Access Compliance Report

Public Rights-of-Way

(Curb Ramps)

Intersection ID: 42579	Main Street: GERALDINE_POWE_DR	Cross Street: STROUD_PARK_CT	Location: NE
ADA ID: 6204C8B74362	Ramp Type: BlendTrans1	Initial Pass/Fail: Fail	Overall Compliance: No
Severity Score: 10			
Codes/Mitigation Info/Possible Solution		Field Measurements/Component Compliance

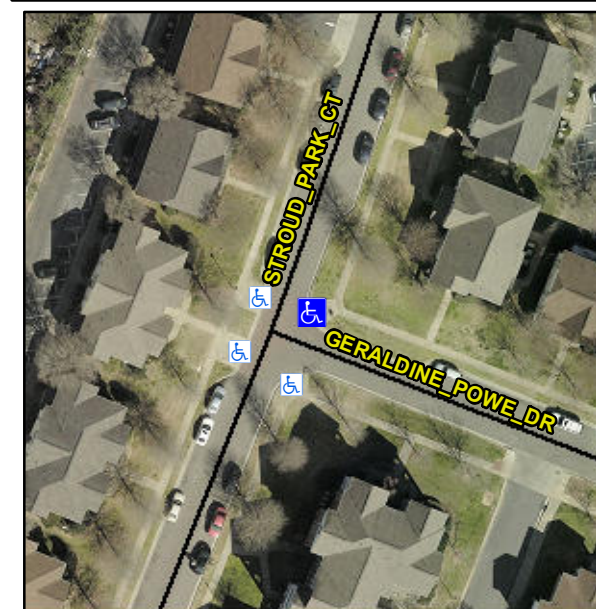
R304.5.1, R304.5.3

Compliance	Description	Data	Compliance	Description	Data
N/A	Ramp Length (in)	138.5	Yes	BlendTrans Slope (%)	4.5
No	Ramp Width (in)	45.0	No	BlendTrans XSlope (%)	4.7
N/A	Flare Type LT	N/A	N/A	Flare Type RT	N/A
N/A	Flare Slope LT (%)	N/A	N/A	Flare Slope RT (%)	N/A
N/A	Flare Traversable LT?	N/A	N/A	Flare Traversable RT?	N/A
N/A	Landing Length (in)	N/A	N/A	DWS Provided?	N/A
N/A	Landing Width (in)	N/A	N/A	DWS Contrast?	N/A
N/A	Landing Slope (%)	N/A	N/A	DWS Length (in)	N/A
N/A	Landing X Slope (%)	N/A	N/A	DWS Full Width?	N/A
N/A	Landing Curb? (Y/N)	N/A	N/A	DWS Offset (in)	N/A
N/A	Shared Landing?	N/A			
N/A	Gutter Ponding?	N/A	N/A	Gutter Slope (%)	N/A
N/A	Gutter Lip Ht (in)	N/A	N/A	Gutter X Slope (%)	N/A
N/A	Painted X Walk1?	No	N/A	Painted X Walk2?	No
	X Walk 1 Direction	To W		X Walk 2 Direction	To S
	X Walk 1 Width (in)	N/A		X Walk 2 Width (in)	N/A
	X Walk 1 Slope (%)	1.0		X Walk 2 Slope (%)	2.5
	X Walk 1 X Slope (%)	3.0		X Walk 2 X Slope (%)	0.2

Remove & Replace Curb Ramp With Two New Directional Ramps or Equivalent.
